**SUBJECT: CALLAWAY PLANT – NRC INTEGRATED INSPECTION  
REPORT 05000483/2019001**

Report Number: 05000483/2019001

Facility: Callaway Plant

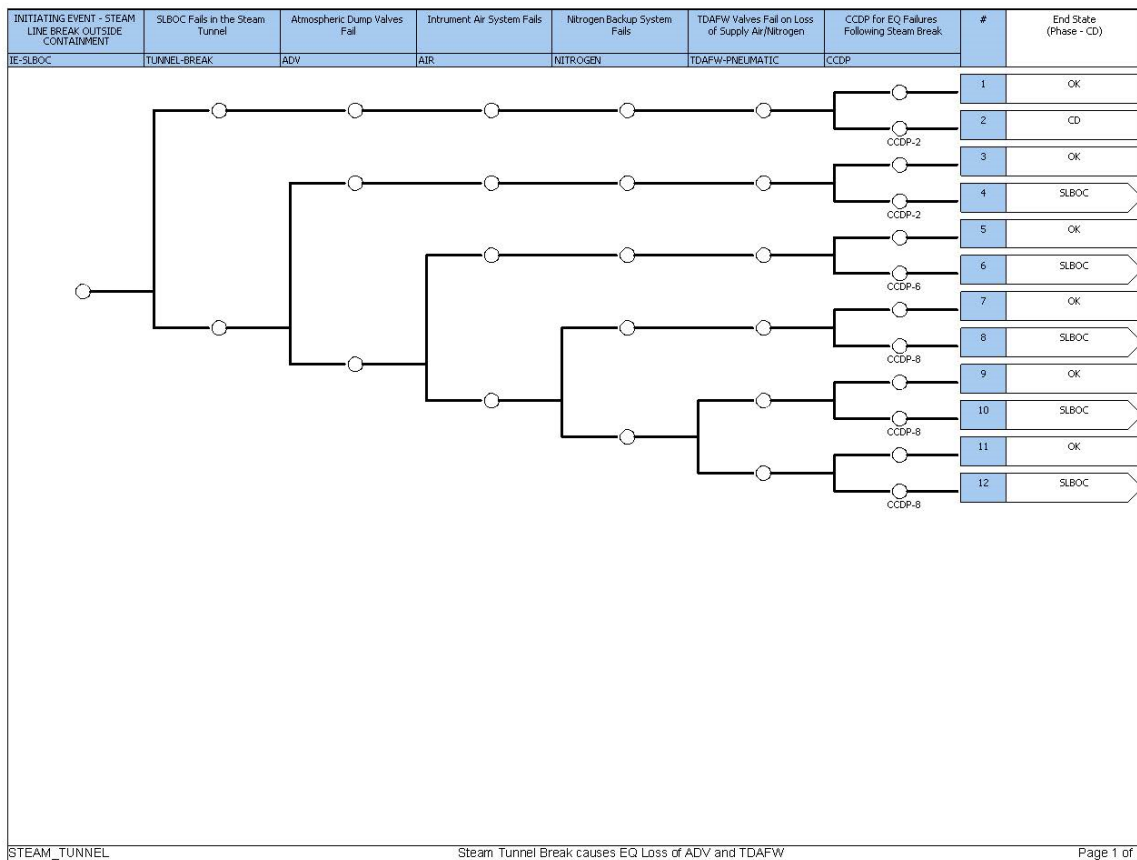
The analyst evaluated the risk of the subject performance deficiency by using the Callaway Plant Standardized Plant Analysis Risk (SPAR) model, Versions 8.50 and 8.54. Additionally, the analyst developed the following event tree to quantify the potential effects of the degraded equipment.

The analyst quantified each of the top events in the event tree as follows:

IE-SLBOC	Using the SPAR model, the analyst determined that the initiating event frequency for a main steam line break outside containment was $6.32 \times 10^{-3}$ /year.
TUNNEL-BREAK	Using pipe length information provided by the licensee, the analyst determined that 19.9 percent of the main steam piping outside containment was inside Area 5, the main steam tunnel, and had the potential to affect the atmospheric dump valve actuators. This represented a failure probability of $1.99 \times 10^{-1}$ .
ADV	As a bounding assumption, the analyst assumed that the atmospheric dump valves would always fail upon a steam line break in Area 5. This represented a failure probability of 1.0
AIR	Using the SPAR model, the analyst determined that the failure probability of the instrument air system failing following a steam line break outside containment was $5.20 \times 10^{-2}$ . The analyst noted that neither the SPAR nor the licensee's PRA provided credit for restoring instrument air compressors that are stripped following a safety injection signal.

NITROGEN	As a bounding assumption, the analyst assumed that the backup nitrogen supply to the turbine-driven auxiliary feedwater train would fail 50 percent of the time from loss, given a failure of the atmospheric dump valve elastomers. This represented a failure probability of $5.0 \times 10^{-1}$ .
TDAFW-PNEUMATIC	Because the auxiliary feedwater valves fail in their current position on loss of air/nitrogen, the analyst assumed that in most scenarios these valves would be in their risk significant position when the nitrogen system depleted. Therefore, the analyst used a screening failure probability of $1.0 \times 10^{-1}$ for the failure of the system caused by the depletion of the backup nitrogen system.

The analyst noted that core-damage Sequences 2 and 4 would not be directly affected by the performance deficiency. Therefore, these sequences were baseline risk and did not need to be quantified. The analyst used the SPAR model Events and Conditions Assessment Workspace to quantify the conditional core damage probability (CCDP) for each of Sequences 6, 8, 10 and 12.
